**Colorado Springs, CO
Planning and Development**

Final Report - Corrections Required
Application No. DEPN-23-0002

Description : proposing to build (4) 3-story apartment buildings with clubhouse and pool

VETERANS VICTORY - LOT 1 DEVELOPMENT PLAN

VETERANS VICTORY - LOT 1
DEVELOPMENT PLAN
DETAILED GRADING (SOUTH)

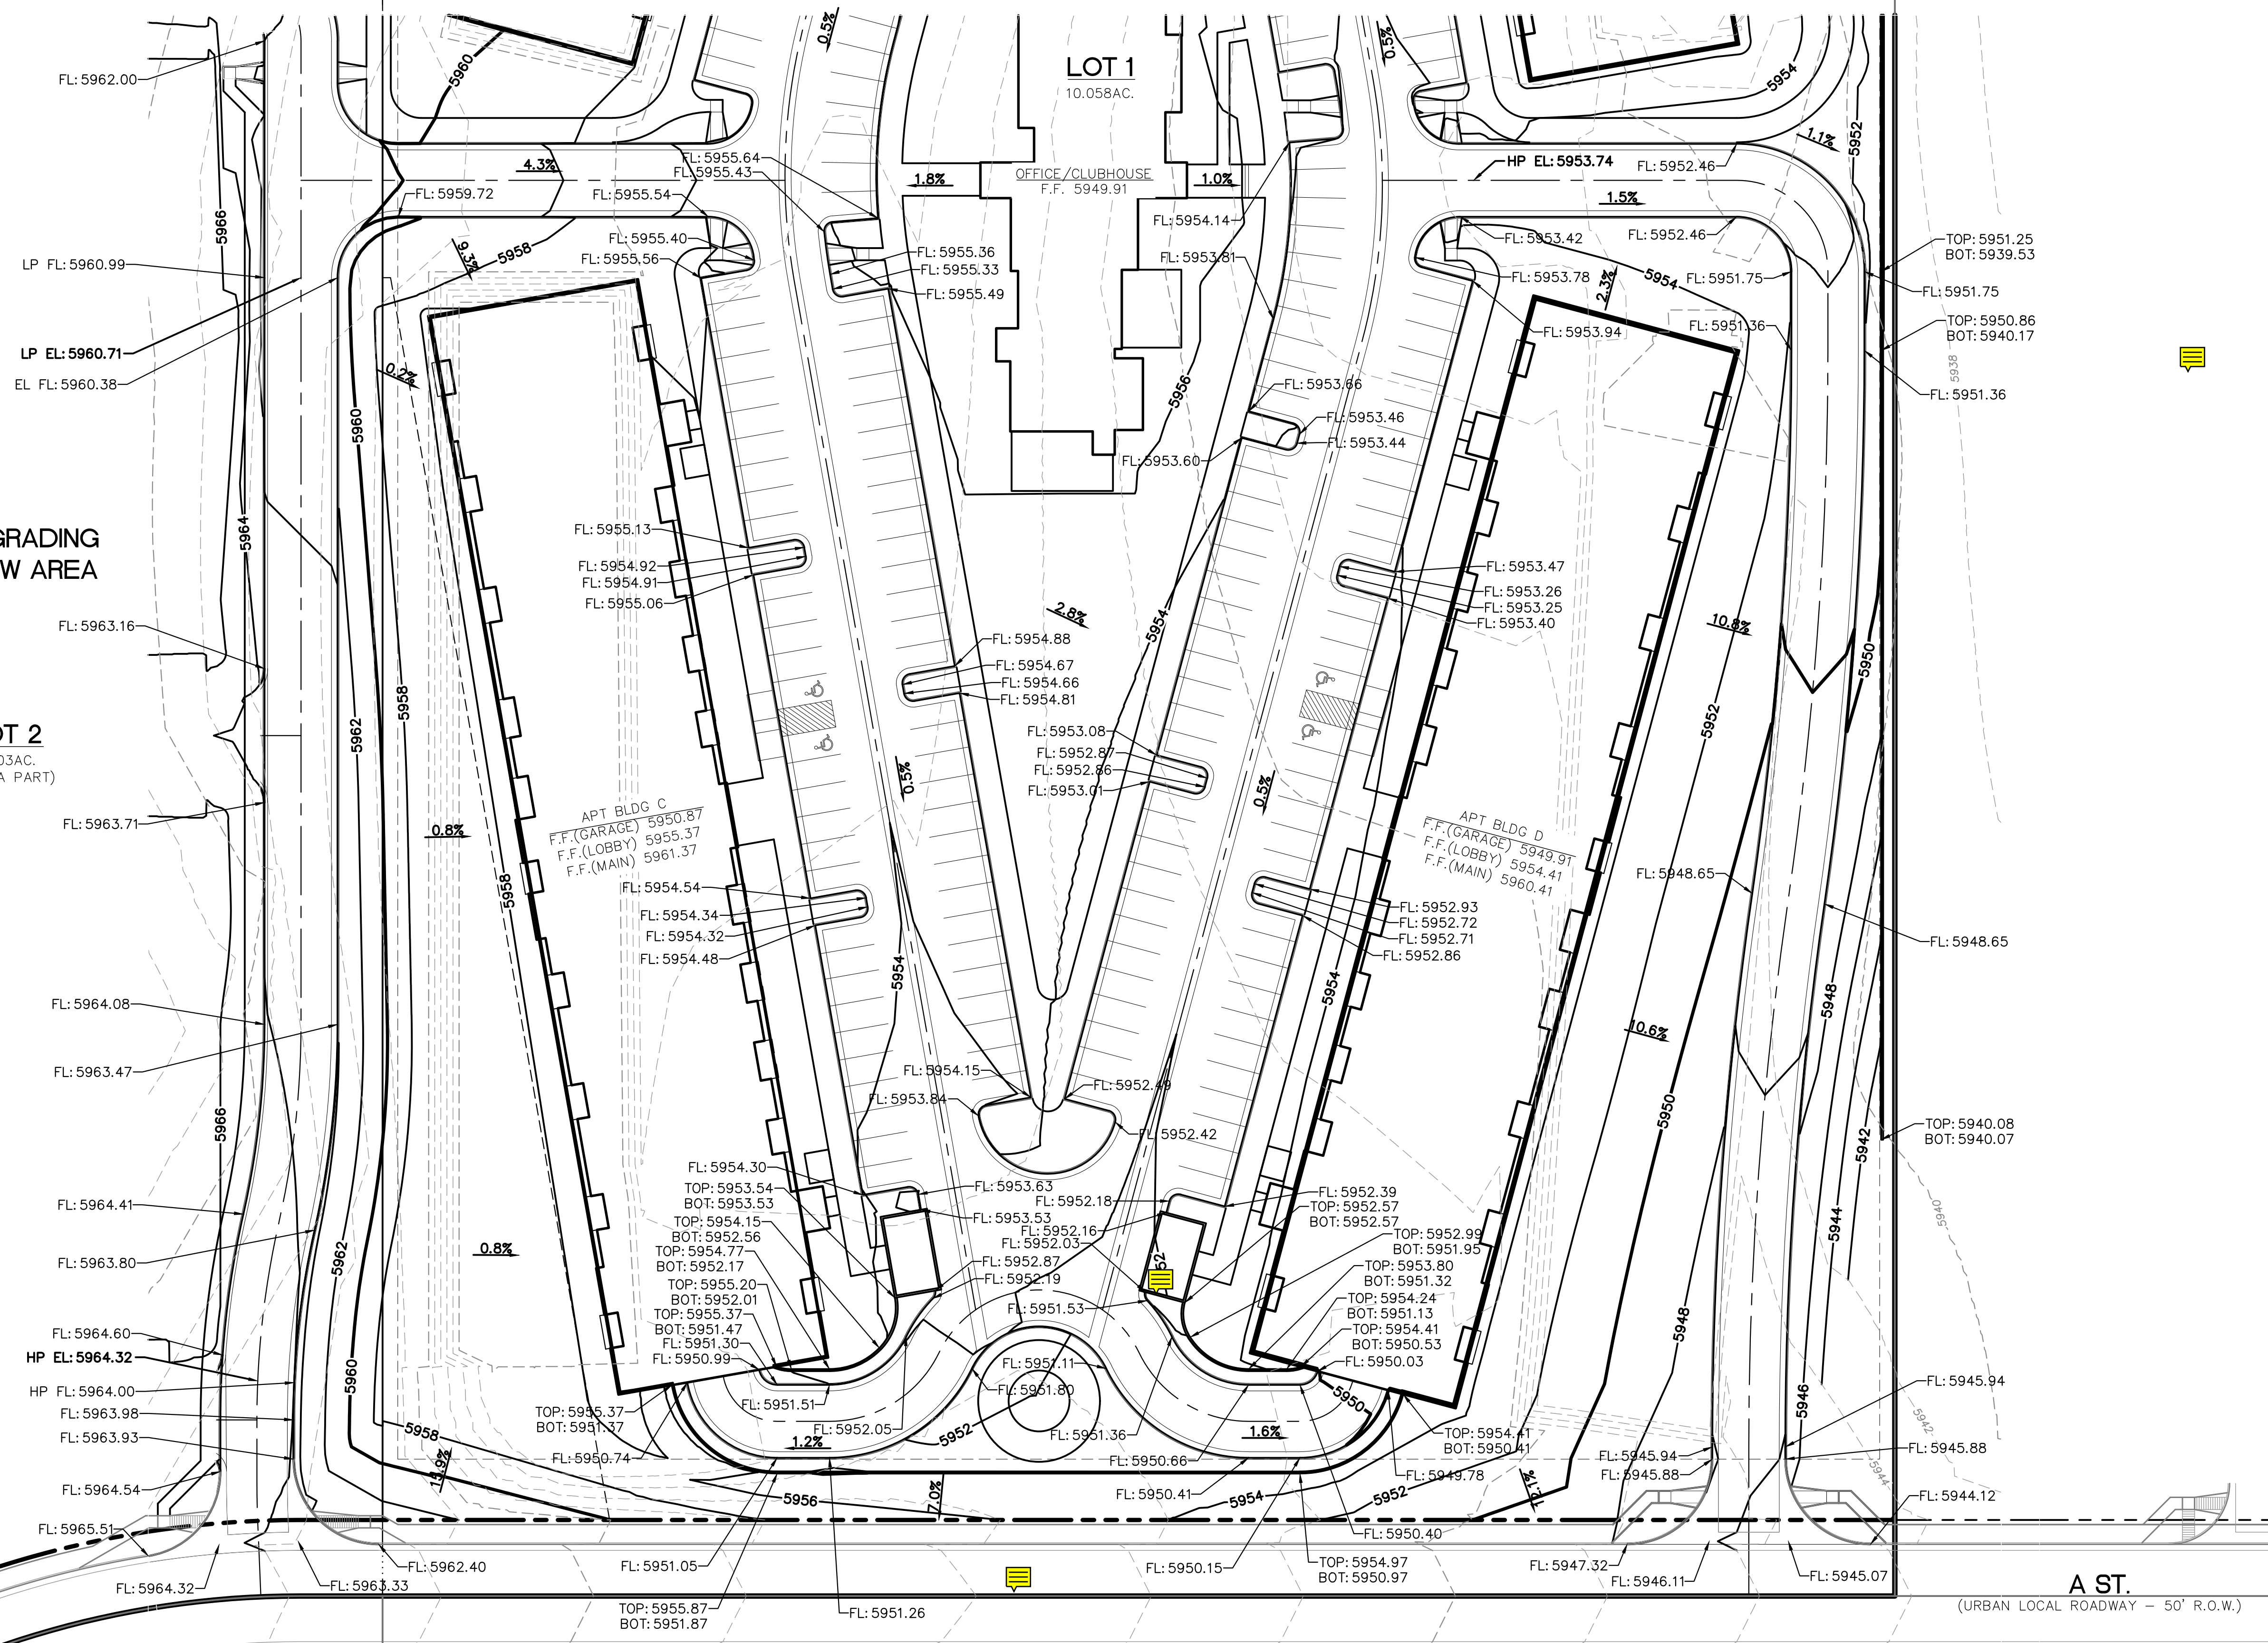
55	5	TJ Gajda : City Engineering - SWENT	Please show pipe infrastructure (pipes, MH, inlets) on grading sheets. It can be labeled on other sheets, but needs to be shown here.
47	6	TJ Gajda : City Engineering - SWENT	Please show pipe infrastructure (pipes, MH, inlets) on grading sheets. It can be labeled on other sheets, but needs to be shown here.
58	6	TJ Gajda : City Engineering - SWENT	Any trash enclosures cannot be placed this close to stormwater inlets. Please move any enclosures that are near an inlet.
61	6	TJ Gajda : City Engineering - SWENT	Label swales (all)
56	7	TJ Gajda : City Engineering - SWENT	Please show pipe infrastructure (pipes, MH, inlets) on grading sheets. It can be labeled on other sheets, but needs to be shown here.
62	7	TJ Gajda : City Engineering - SWENT	Please show pipe infrastructure on grading sheet. It can be labeled on other sheets, but needs to be shown here.
63	7	TJ Gajda : City Engineering - SWENT	Label swales (all)

**DEVELOPMENT PLAN
STORM SYSTEM**

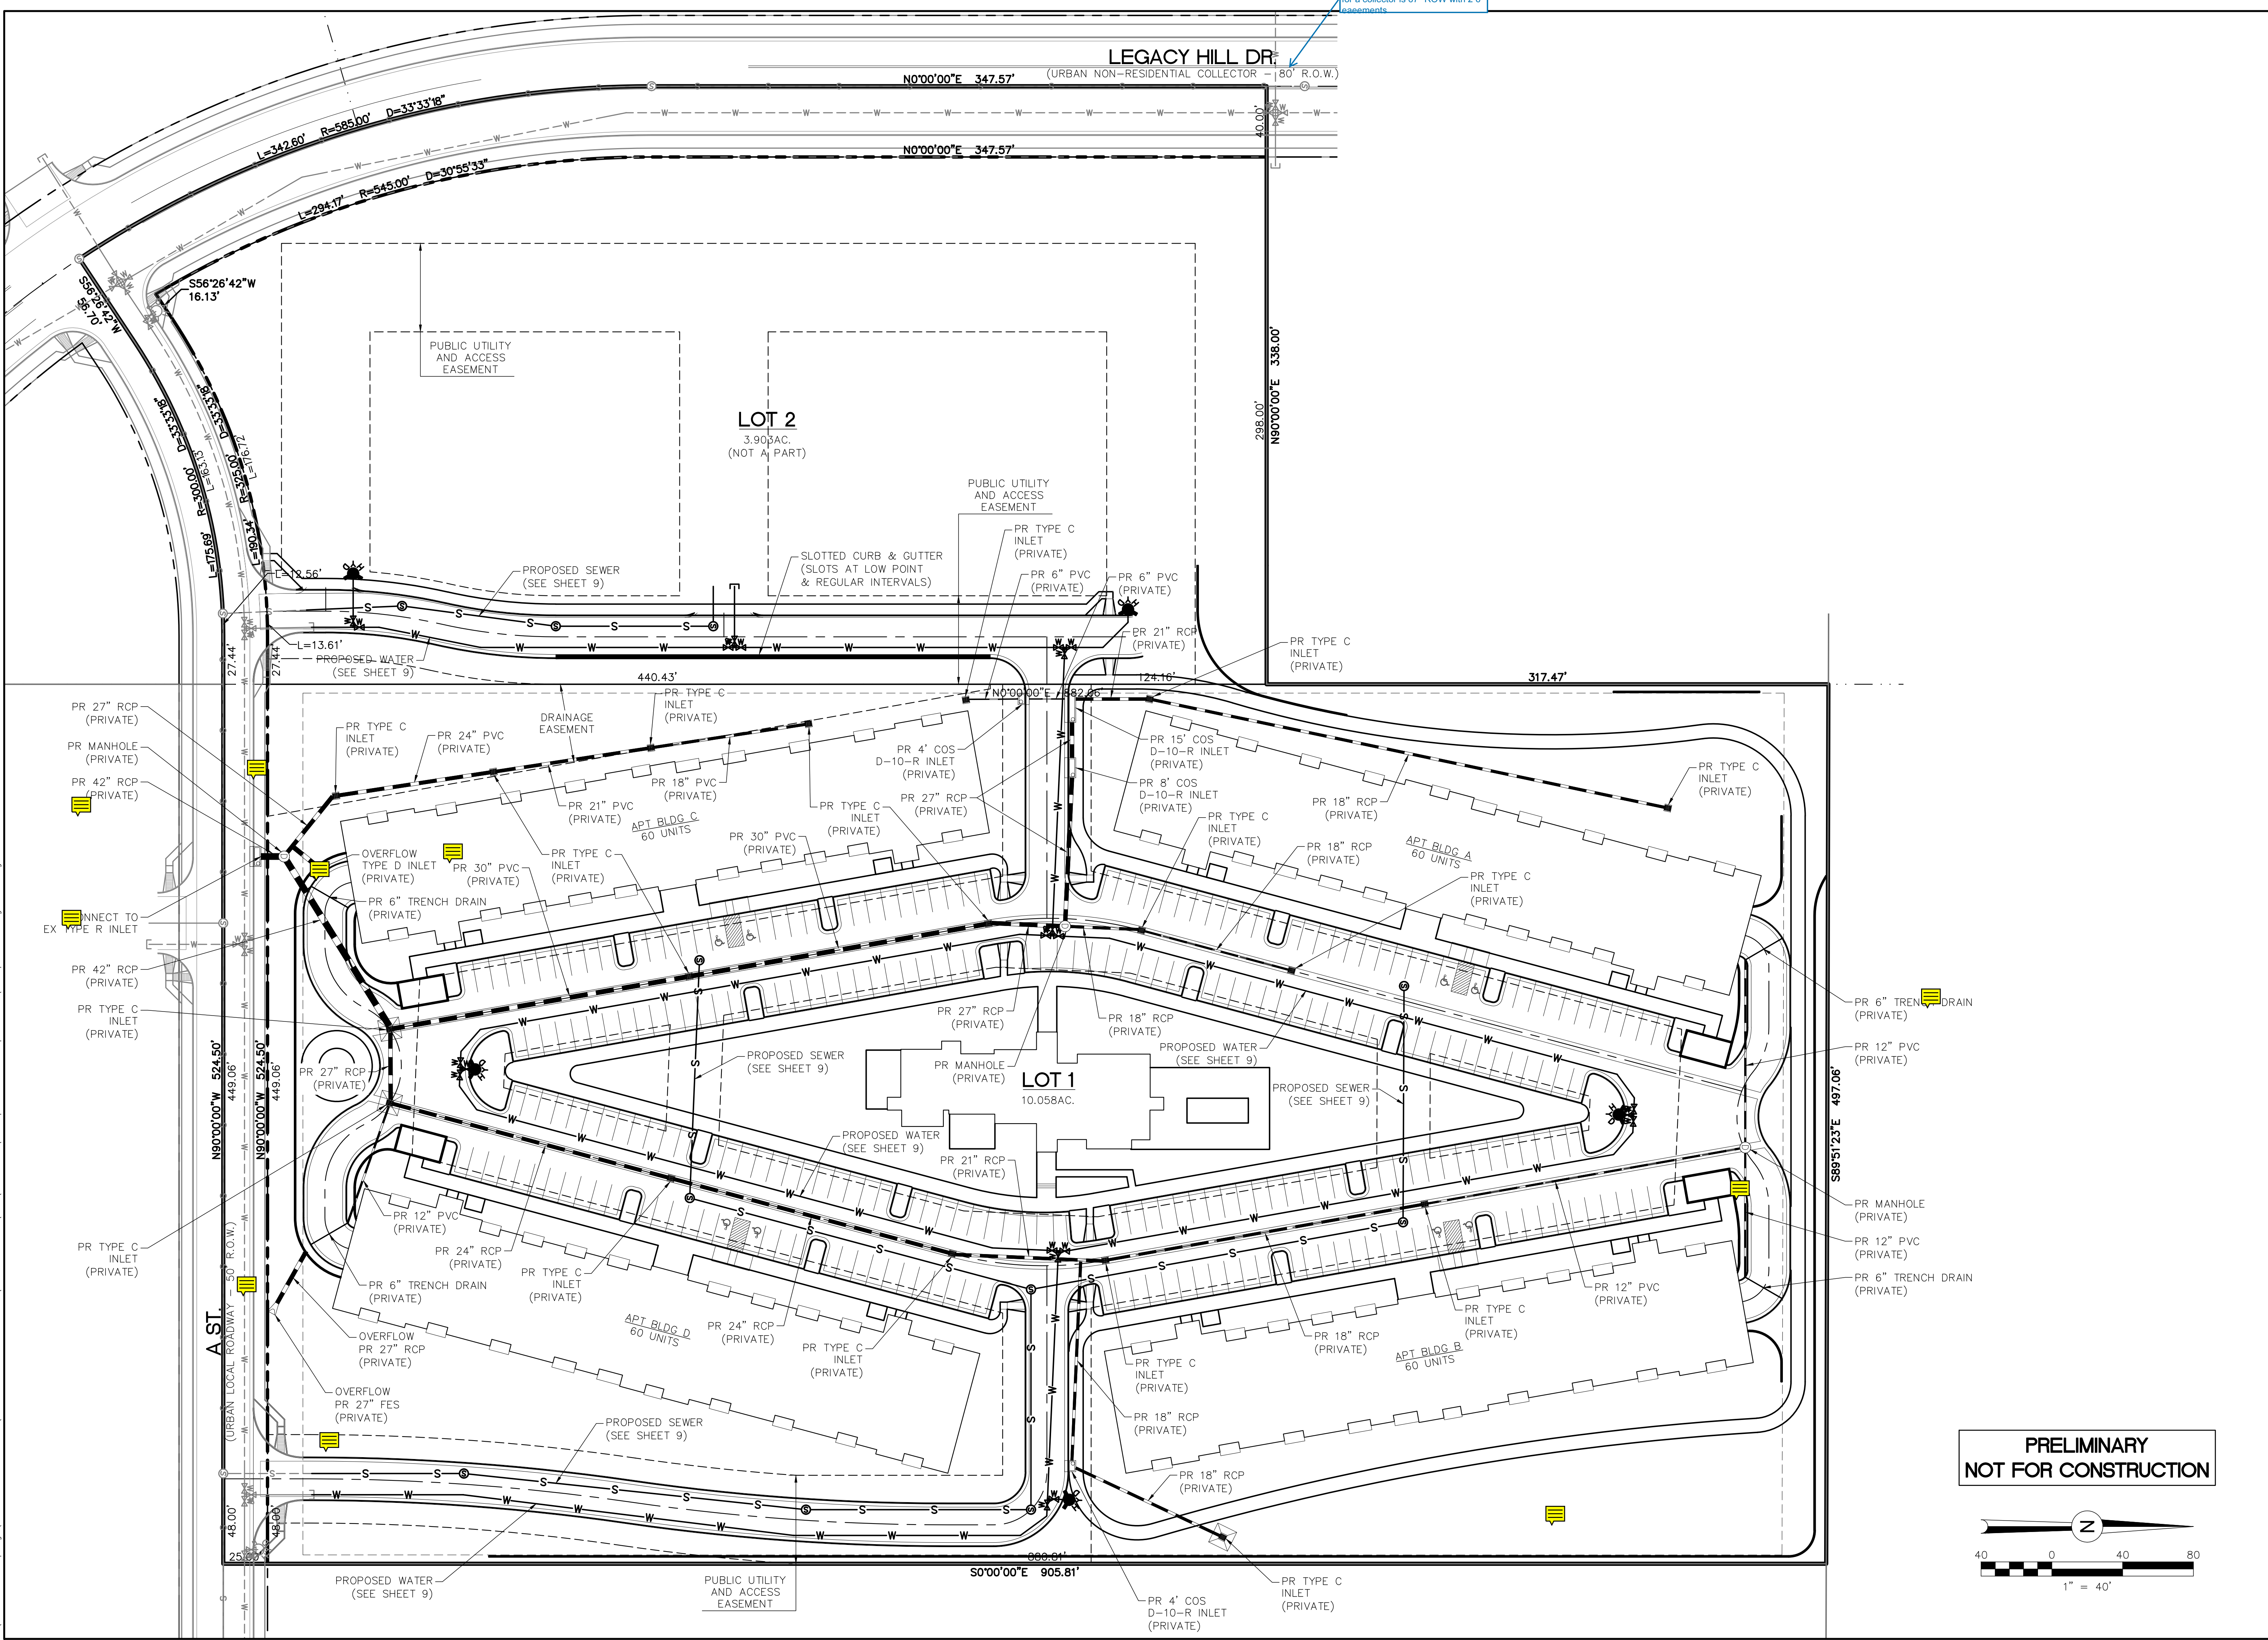
65	7	TJ Gajda : City Engineering - SWENT	Is there a swale to get flows to go to this inlet? (not shown)
41	8	TJ Gajda : City Engineering - SWENT	Add MH types
42	8	TJ Gajda : City Engineering - SWENT	What is the pipe leaving this inlet? 42" pipe leading into it is quite large.
43	8	TJ Gajda : City Engineering - SWENT	This is a very large pipe connecting to the inlet. While private pipes can use inlets as junctions, It must fit within the standard inlet (existing) without modification to meet DCM.
44	8	TJ Gajda : City Engineering - SWENT	This pipe is not labeled. It should connect to the MH.
45	8	TJ Gajda : City Engineering - SWENT	What is the purpose of this overflow pipe? Is there no curb capacity? The inlet must have capacity. Trench drains tend to clog more than standard inlets. Please use standard inlet with capacity and no overflow pipe.
49	8	TJ Gajda : City Engineering - SWENT	I have not seen any FDR with calculations of pipes or ponds that will receive this site's flows. I cannot do a full review without knowing that full spectrum detention and the four step process is addressed.

51	8	TJ Gajda : City Engineering - SWENT	Pipe confluence cannot be >90 degrees.

Comment ID	Page Reference	Author : Department	Review Comments
52	8	TJ Gajda : City Engineering - SWENT	What happens to flows if these trench drains (north end) clog?
53	8	TJ Gajda : City Engineering - SWENT	Green infrastructure flows will not work as proposed in this area. Impervious areas must be treated with FSD, and the WQ reduction for this area would not meet that. Is there capture downstream that would resolve this?
48	9	TJ Gajda : City Engineering - SWENT	Please see previous sheet for stormwater comments and resolve here as applicable.
57	11	TJ Gajda : City Engineering - SWENT	Any trash enclosures cannot be placed this close to stormwater inlets. Please move any enclosures that are near an inlet.
60	11	TJ Gajda : City Engineering - SWENT	Label swales (all)
46	12	TJ Gajda : City Engineering - SWENT	The outfall of a pipe shouldn't be over sidewalk. It should have erosion protection.
59	12	TJ Gajda : City Engineering - SWENT	Any trash enclosures cannot be placed this close to stormwater inlets. Please move any enclosures that are near an inlet.
